PLANNING AND ZONING BOARD/BOARD OF ZONING APPEALS MEETING AGENDA

**Tuesday, February 25, 2025
7:00 PM**

3. Review of SP-2025-03, application of Rodney Bruntz, pursuant to City Code 17.12, who is petitioning to build a 4,050 sq. ft. commercial building on property currently addressed as 595 W Clay, Valley Center, KS 67147.

Date: February 25, 2025

LANDSCAPE PLAN

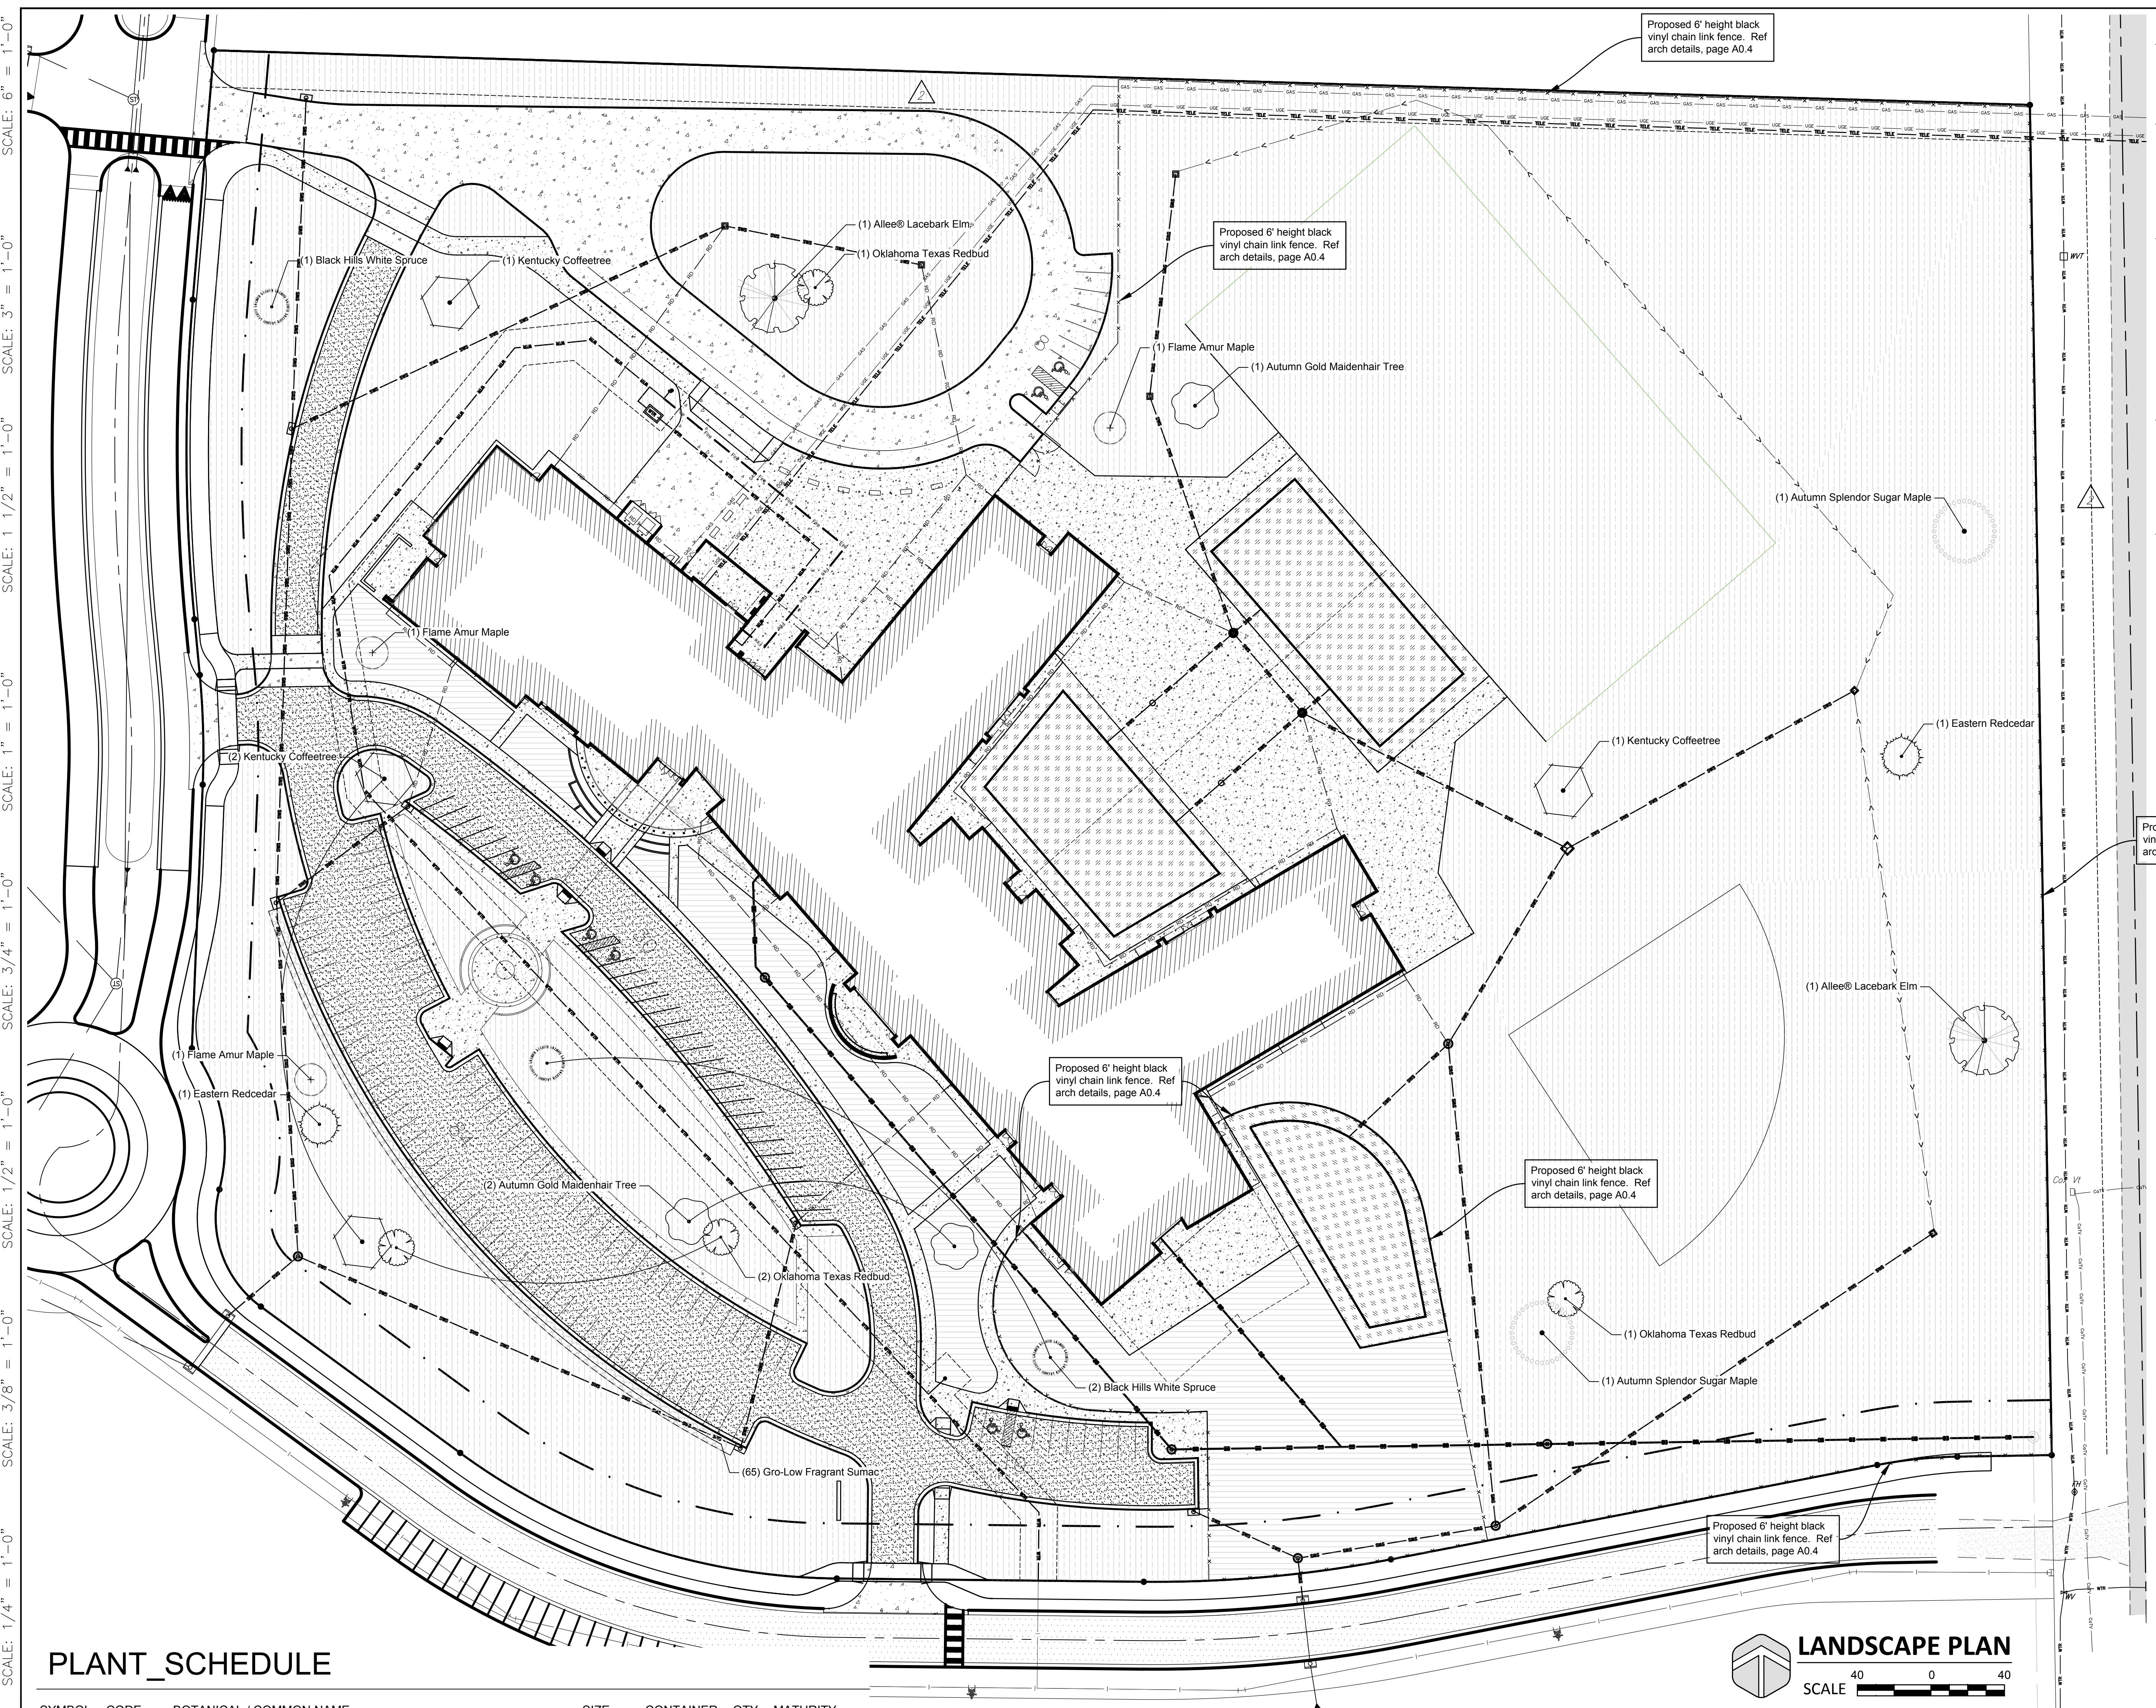
- The landscaping plan shows a variety of 23 trees, 65 shrubs and grass being planted across the entire site, not just the first 10 feet.

- Fencing will be 6' chain link, as depicted on the plan, the common and botanical names are listed on the plan as well as the size of each when planted.

Screen Plan

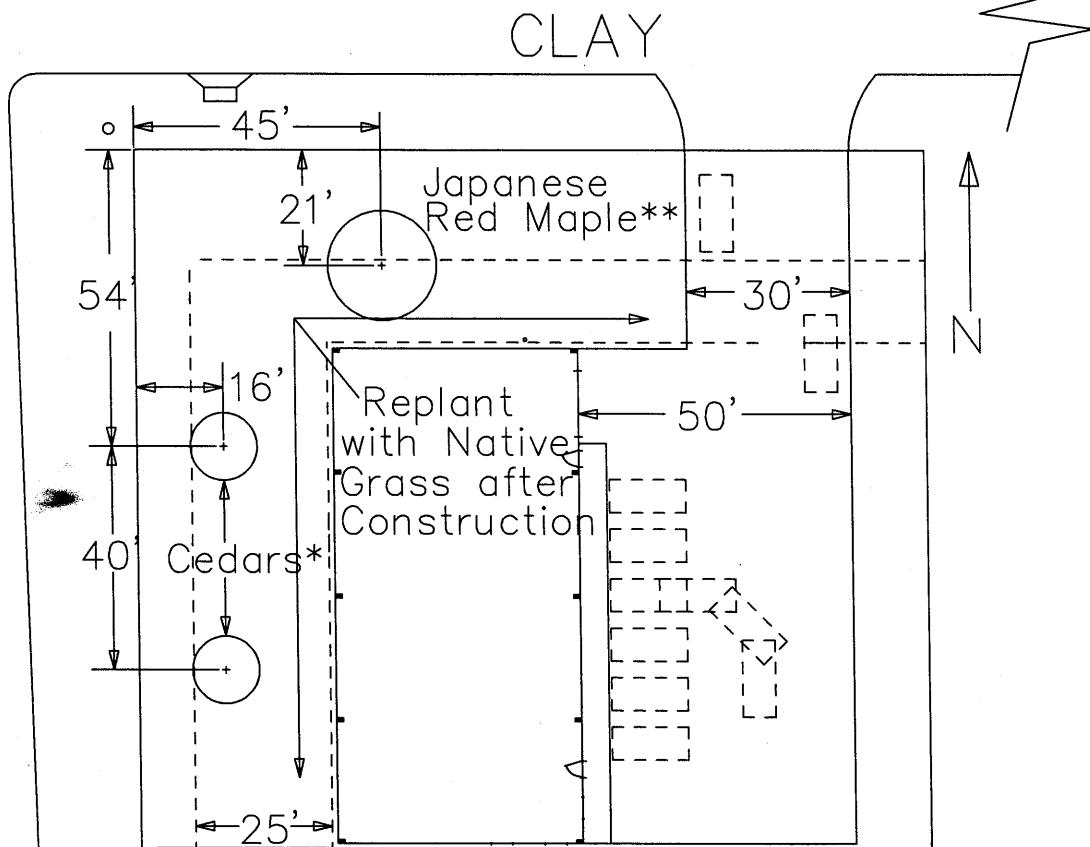
- Fencing will be 6' wood, as depicted on the plan, the common and botanical names are listed on the plan as well as the size of each when planted, grass will either remain on-site or be replanted where construction tears it up.

STAFF RECOMMENDATION: City staff recommends that the Planning and Zoning Board require at least 6 Cedar trees to screen the west side of the building. From the specifications in the plan each cedar will have a 13' spread at maturity, only screening 26' of the 90' building. 6 Cedar trees would screen 78' of the 90' building. All other screening requirements are recommended for approval.
